PLANNING AND ZONING BOARD STAFF REPORT

Conklin Car Wash

Meeting	File No.	Application Type
November 17, 2025	2025-109 -SPR-LV4 (Site Plan) 2025-110-USE-PZB (Conditional Use)	Level 4 Site Plan & Conditional Use
Property Owner / Applicant	Authorized Agent	
Andella Holdings, LLC	Bradley Miller, AICP-Urban Design Studio

Provide a recommendation to the City Commission on a request for a Level 4 Site Plan Application with Architectural Elevations and Landscape Plan, including a Conditional Use (Resolution No. 210-25) to allow a 4,207 square foot automatic car wash at 14145 South Military Trail.

Figure 1. Attachment G: Noise exposure map

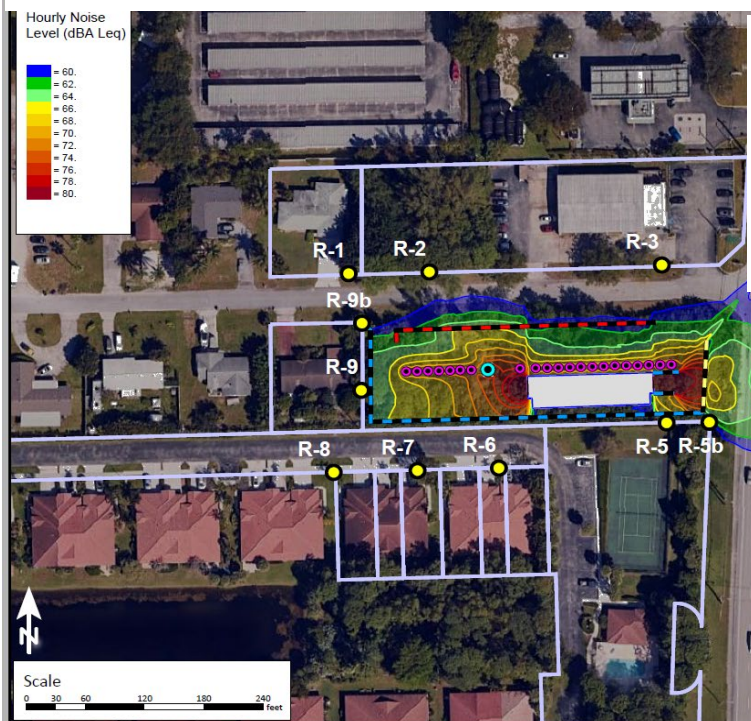
The performance standards incorporate good planning practices by requiring analysis of noise, odors, dust, and traffic volumes to prevent degradation of the surrounding area and to maintain the safety, livability, and stability of adjacent properties. A noise study was requested and submitted by the applicant. The submitted operational noise analysis concluded that noise levels at all 11 receptors do not exceed the City's exterior noise standard of 60 dBA when measured at the neighboring property line. A noise exposure map, provided in Attachment G of the noise study, illustrates noise contour lines and levels of dBA. Table B illustrates that the proposed unwanted sounds levels are contained within the site and do not cross the property line of adjacent land uses. Although Table B lists all receptors with noise levels below 60 dBA, two specific points of concern are receptor number R-5B, located at the southeast corner of the property, with an operational noise level of 59.4 dBA. The receptor is adjacent to an amenity area belonging to the Sierra Vista residential community to the south. Additionally, receptor number R-9B at the northwest corner of the property has an operational noise level of 56.4 dBA. This receptor directly abuts a single-family residence to the west.

Figure 2. Table B: Noise Levels

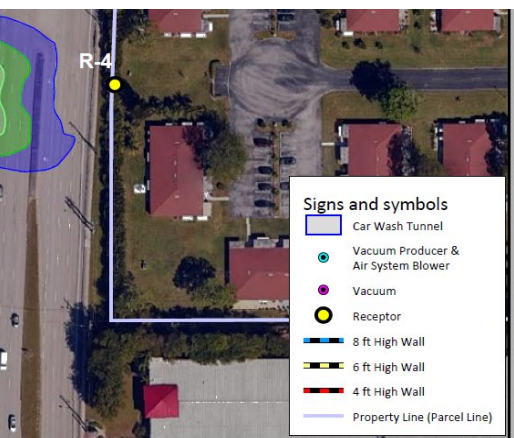
The applicant has incorporated several sound buffering measures to mitigate noise impacts to adjacent residences. The site design includes an 8-foot masonry wall with landscape screening along the southern and western boundaries, as well as 8-foot-high block walls just north and south of the exit of the car wash tunnel. The tunnel exit is oriented toward the major roadway to direct noise away from residential areas and is supplemented by a 6-foot-high wall with landscaping. Along the northern property line, abutting Conklin Drive, a 4-foot-high masonry wall with landscape is proposed to provide additional screening. Furthermore, the applicant proposes to install silencers on the dryers and the vacuum producers will be surrounded by a 6-foot-high wall. The proposed hours of operation are from 7:00 am until 9:00 pm daily. The Board should consider whether these soundproofing measures are sufficient to mitigate potential noise impacts or whether additional attenuation is warranted to ensure that noise levels remain below the 60 dB threshold established by the City's noise ordinance.

- Whether these soundproofing measures are sufficient to mitigate potential noise impacts or whether additional attenuation is warranted to ensure that noise levels remain below the 60 dB threshold established by the City's noise ordinance.

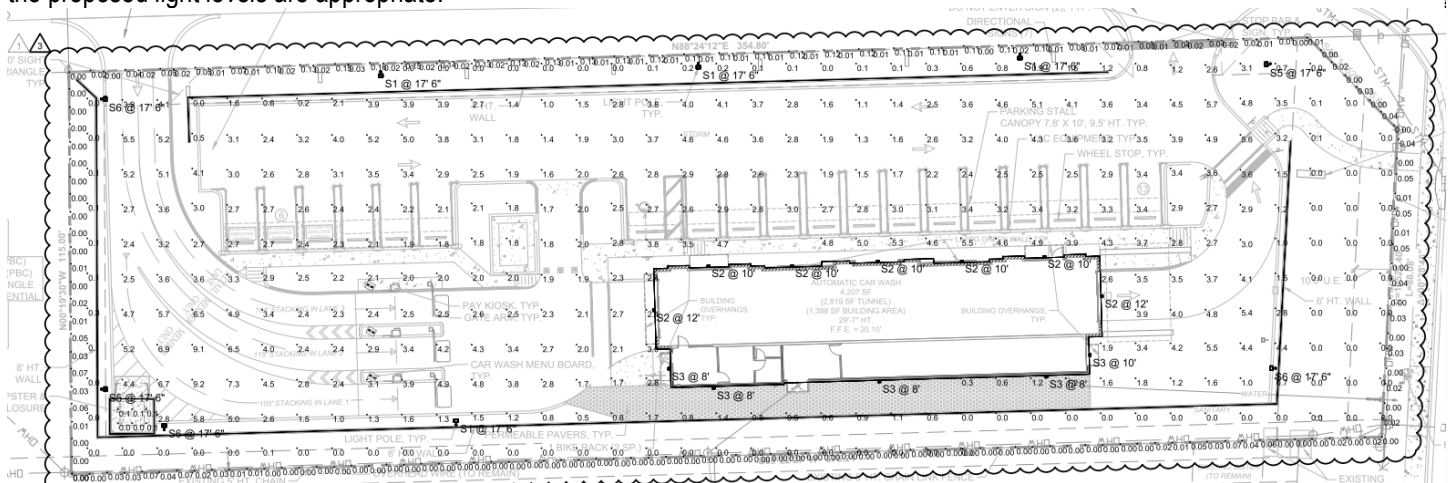
All services associated with the automatic car wash will be conducted within the enclosed building, except for the use of free vacuums, which are located outside, accessible from the 19 parking spaces. Activities associated with outside conditional uses are allowed **when it is specifically determined through the conditional use process that the outside aspects of the use are appropriate**. The outdoor vacuums must be specifically considered and approved by the Board. Conditions may be applied to mitigate visual and other impacts.

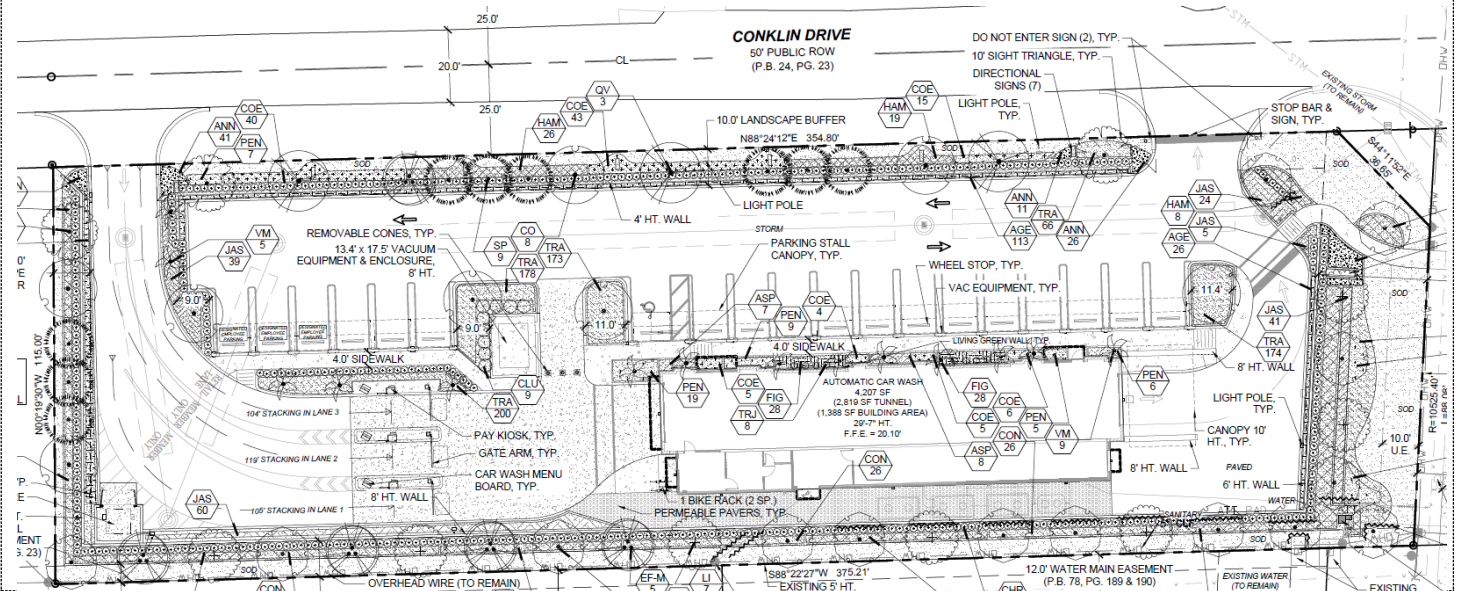
The landscaping plan for the proposed development has been evaluated for consistency with LDR Section 4.6.16. The project incorporates a lush and substantial landscape design along the perimeter of the site (image below and attached as full size).

The proposed development will provide and exceed the minimum buffering and landscaping around its perimeter. On the east perimeter, along South Military Trail, a required 30-foot special landscape buffer is provided with a 6-foot masonry wall, fully landscaped with Crape Myrtle and Spanish Stopper trees, layered with Penta and Minima Jasmine shrubs and ground cover. The perimeter buffer continues with an 8-foot-high masonry wall along the south and west property to include a 10-foot landscape buffer lined with Spanish Stopper, Crape Myrtle, and Southern Live Oaks, layered with various shrubs and ground cover. On the north perimeter along Conklin Drive, a 10-foot landscape buffer is provided to include a 4-foot-high masonry wall, heavily landscaped with three Southern Live Oaks, eight Green Buttonwood trees, two Pink Tabebuias, nine Sabal Palmetto, and one Spanish Stopper.

Figure 2. Project Location & Land Use

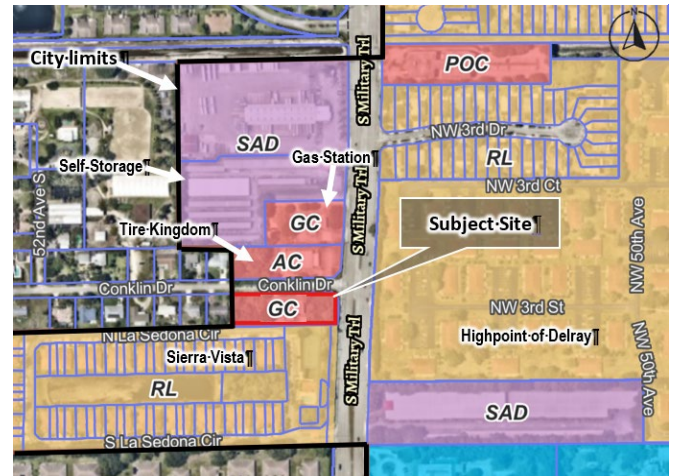
The subject property directly abuts residential property to the west and south. Across Conklin Drive to the north is an automotive-retail/service store (Tire Kingdom), and across South Military Trail to the east is the High Point of Delray residential community. The surrounding zoning, land use, and uses are outlined in Figure 2 and the table below:
